ADDENDUM NO. 2

Reference: Audio Visual Integration – Utah Museum of Natural History
University of Utah
DFCM Project No. 02243750

Addendum #2
May 5, 2009

RAA Project No. 0275
U. of U. Project No. 0872-9630
DFCM Project No. 02243750
Sheet No.
AV - 130

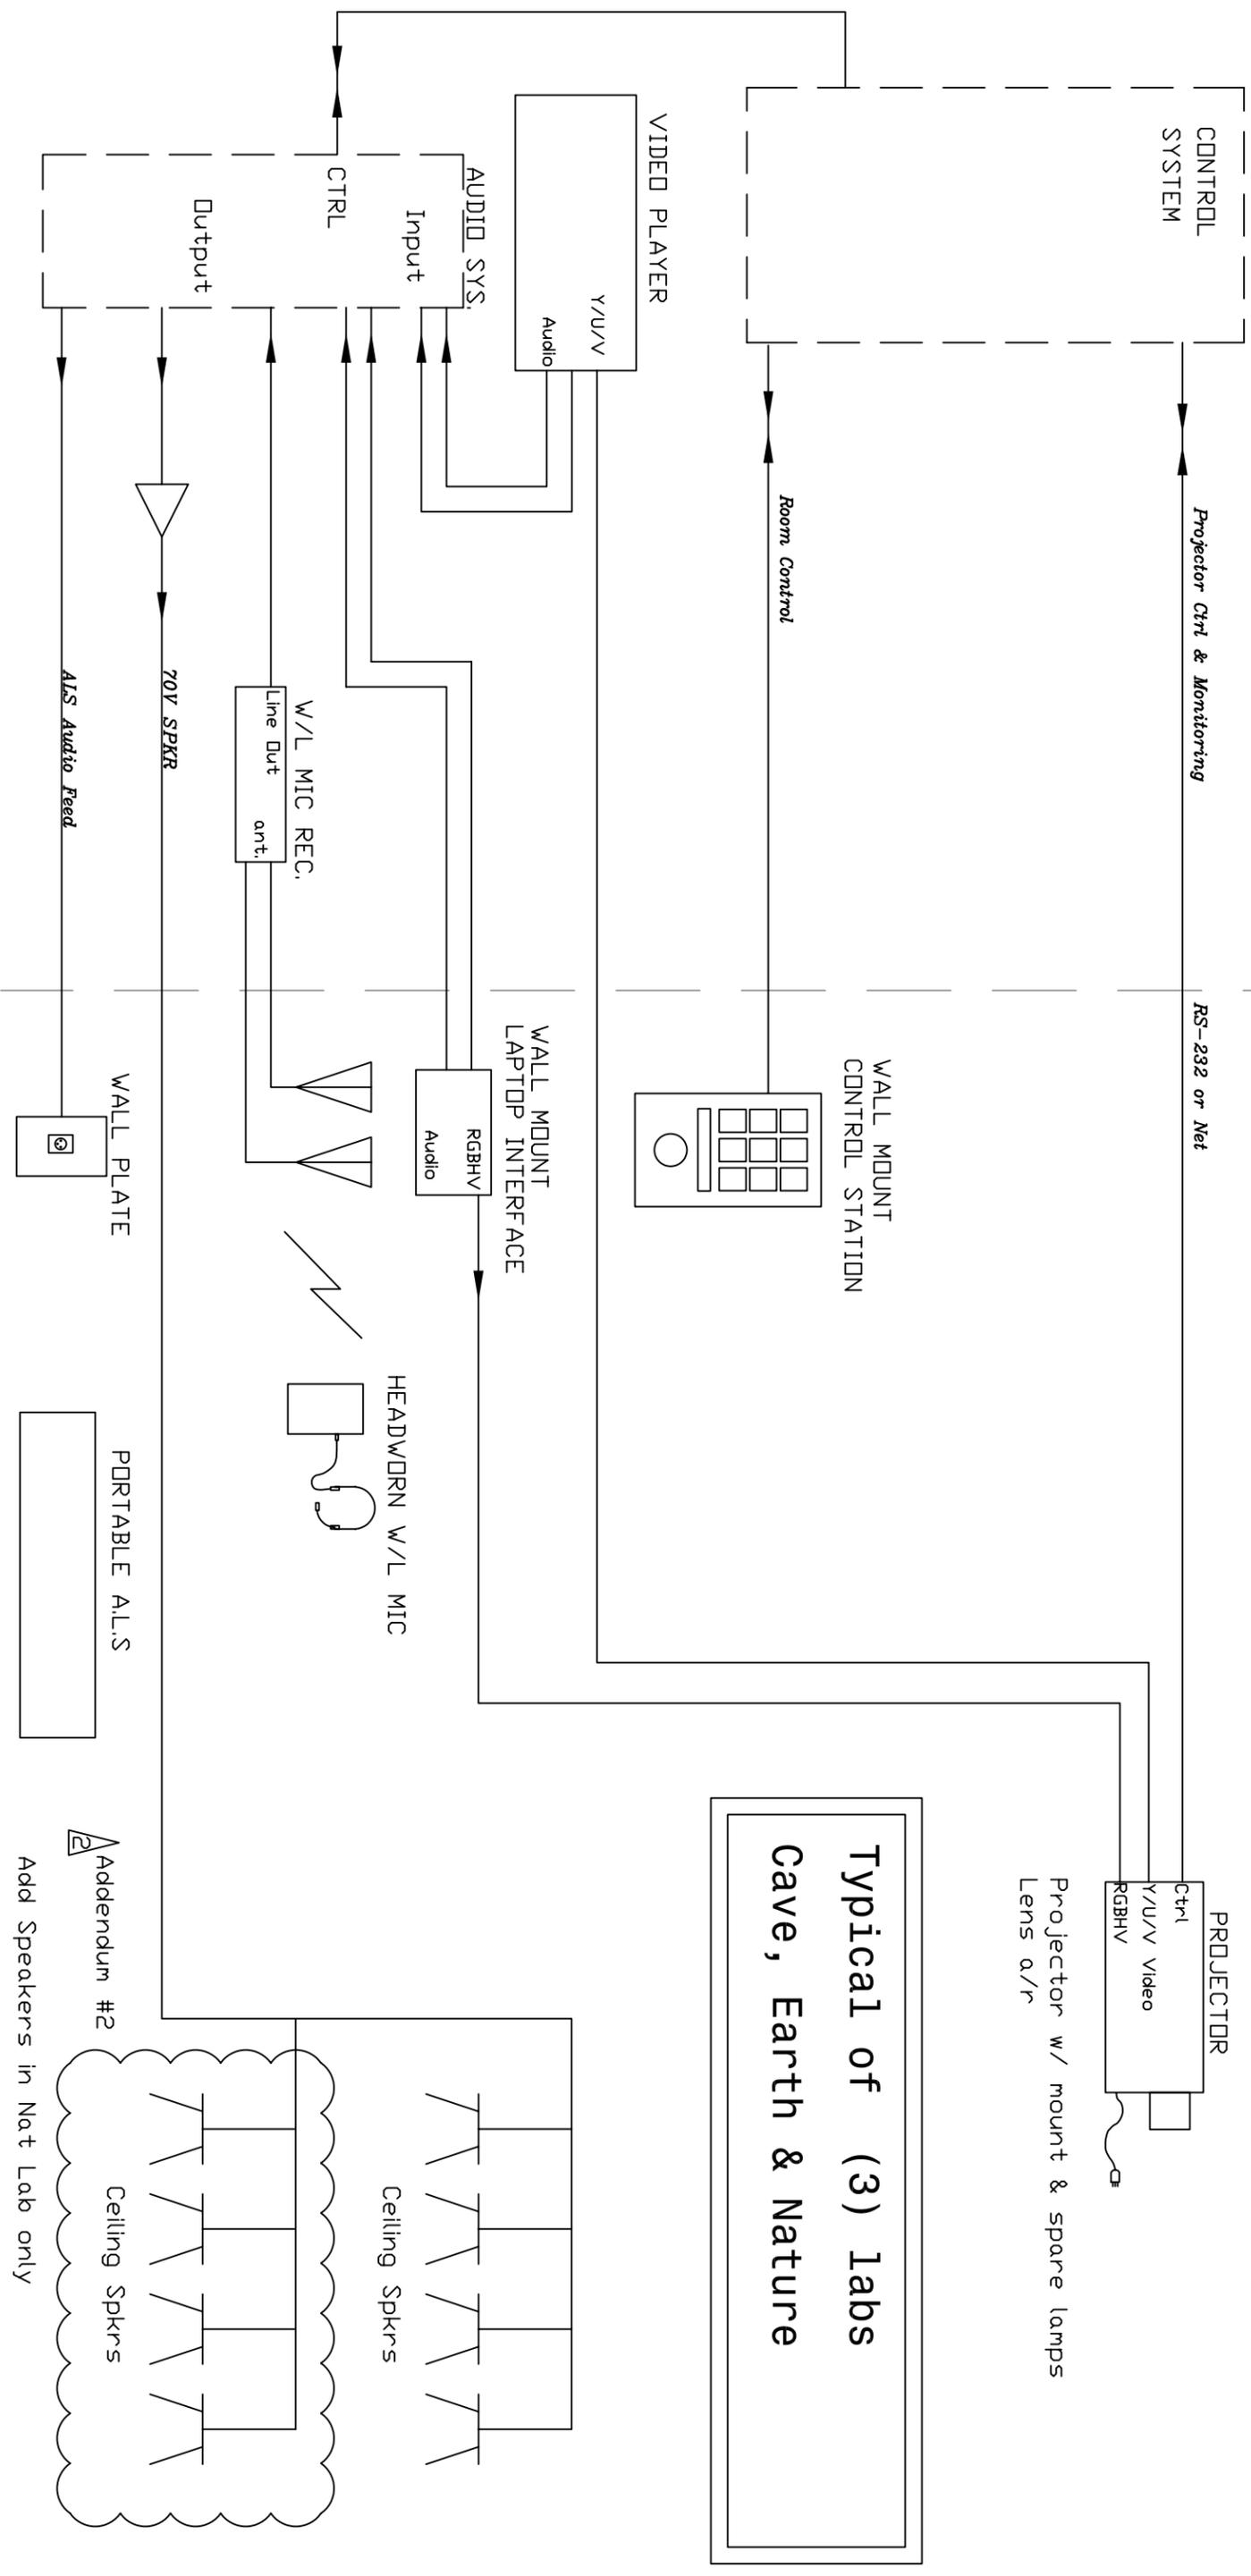
Increase qty of speaker in Naturalist Labs from 4 to 8
